Department of Transportation

MEMORANDUM

SUBJECT: BZA Case No. 20643 – 5901 Utah Avenue NW (Maret School Athletic Field)

Figure 1 | Site Plan and Curbside Plan

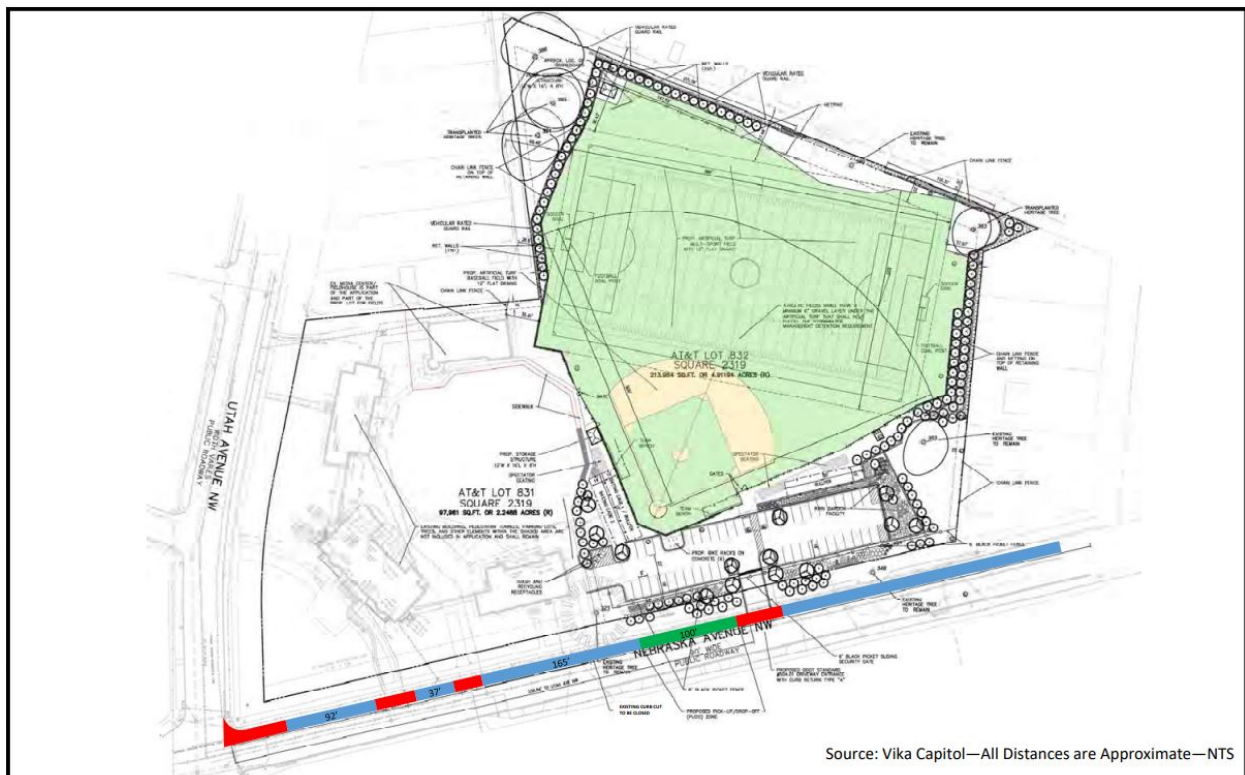
Pedestrians access the field will be via a leadwalk from Nebraska Avenue adjacent to the vehicle entrance. Pedestrians have a direct path to access the fields through the parking lot. Vehicular access to the parking lot is proposed via a 24-foot curb cut on Nebraska Avenue. Additionally, the Applicant proposes a 100-foot curbside pick-up/drop-off zone along Nebraska Avenue to ensure smooth operations. While this site is adjacent to a public alley to the north and west, DDOT has upgraded it to a green alley and it is not recommended to be used due to the projected vehicle volumes of the field and circuitous route. The Applicant will be closing an existing curb cut along Nebraska Avenue and providing one (1) new access point for vehicular access and trash pick-up. Figure 1 below shows the site layout of the proposed project, as well as the proposed changes to curb side designations (blue represents unrestricted parking, red is 'no parking', and green the bus pick-up/drop-off zone). DDOT finds the proposed curbside changes generally acceptable and will go through a formal review and approval during public space permitting.

While the preliminary public space plans, shown above in Figure 1, are generally consistent with DDOT standards, there are a few considerations that need to be reviewed in greater detail during the public space permitting process:

- DDOT concurs that the existing curb cut on Nebraska Avenue NW should be closed. The existing driveway in public space and within the Building Restriction Line dimension should be removed and replaced with green space and a street tree in the furniture zone;

- Ensure there is a leadwalk to the sports field for pedestrian access. The design will be reviewed in the public space construction permit application;

- The public space permit application should include designs of all bicycle and pedestrian network improvements included as BZA conditions;
- Submit a curbside management plan for the curbside designations along Nebraska Avenue NW including any pick-up/drop-off zones. Applicant will be required to fund and install any changes to signs or meters; and

- The garden at 5860 Nebraska Avenue NW, within public space, will be disturbed by the installation of a gas line. This garden should be shown on the public space plans and substantially restored after construction of the gas line.

Figure 2 | On-Street Parking Inventory

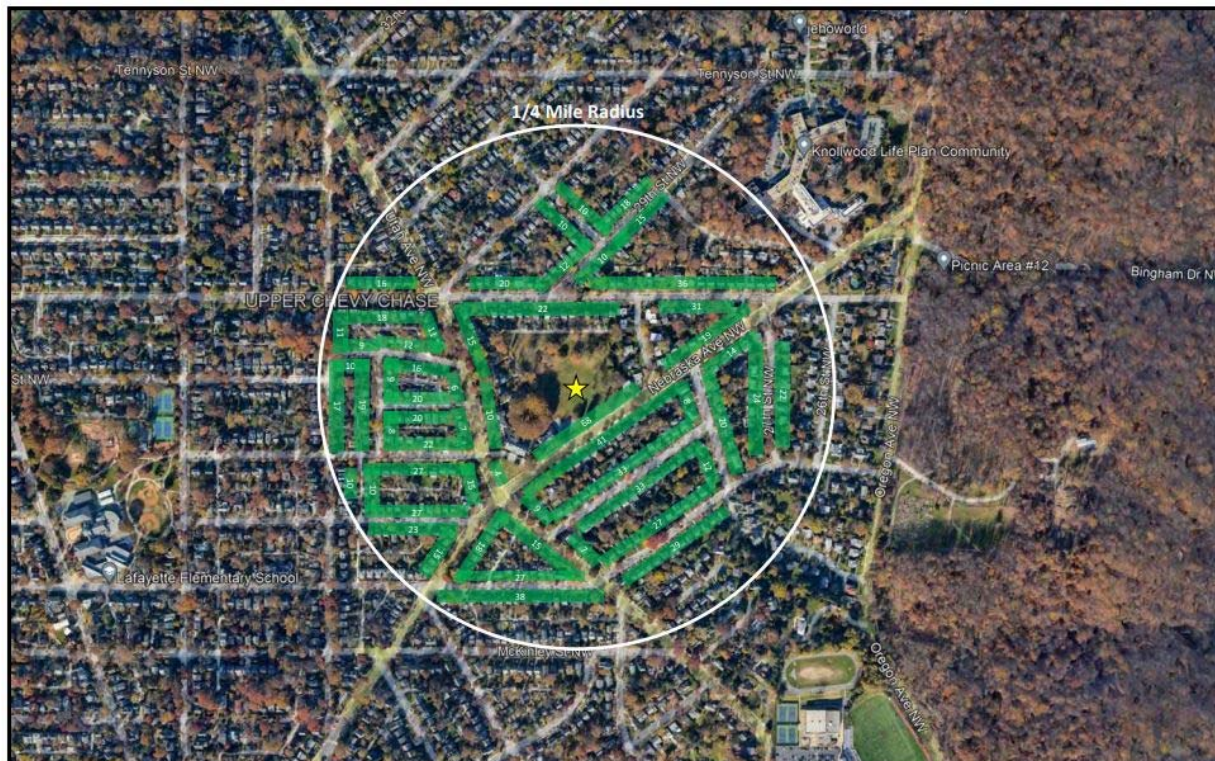
The CTR also provided an on-street parking assessment of the streets within a ¼ mile radius of the site. Approximately 1,178 total on-street parking spaces were identified in the study area and occupancy was approximately 44 percent during both weekday and Saturday peaks (7:00 PM and 8:30 AM, respectively). As shown below in Figure 2, the Nebraska Avenue NW block face adjacent to the athletic field has 68 on-site parking spaces in the event the 48 on-site parking spaces are full. Additionally, there are another 41 on-street spaces along the opposite side of Nebraska Avenue.

Figure 4 | Existing and Proposed Bicycle Facilities

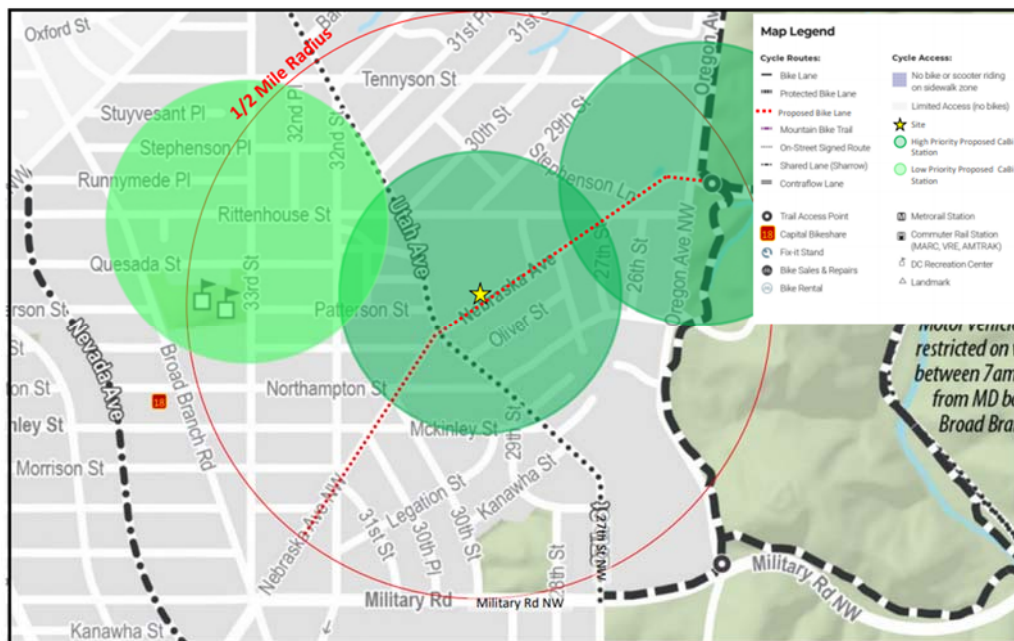
The District is committed to enhancing bicycle accessibility by ensuring consistent investment in bicycle infrastructure on the part of both the public and private sectors. DDOT expects new developments to serve the needs of all trips they generate, including bicycling trips. As shown below in Figure 4, there are currently no bicycle lanes or Capital Bikeshare stations in the vicinity of the site. DDOT has identified Nebraska Avenue as a future bicycle connection but has not identified the timeframe for planning or the type of facility. DDOT has also identified this area as a high priority for Capital Bikeshare and will work with the Applicant to identify a location for a new Capital Bikeshare station.

- Fund and install a 19-dock Capital Bikeshare station with 12 bikes and one (1) year cost of maintenance and operation; and
- Install a minimum of eight (8) inverted-U bicycle racks for a minimum total of 16 short-term bicycle parking spaces.
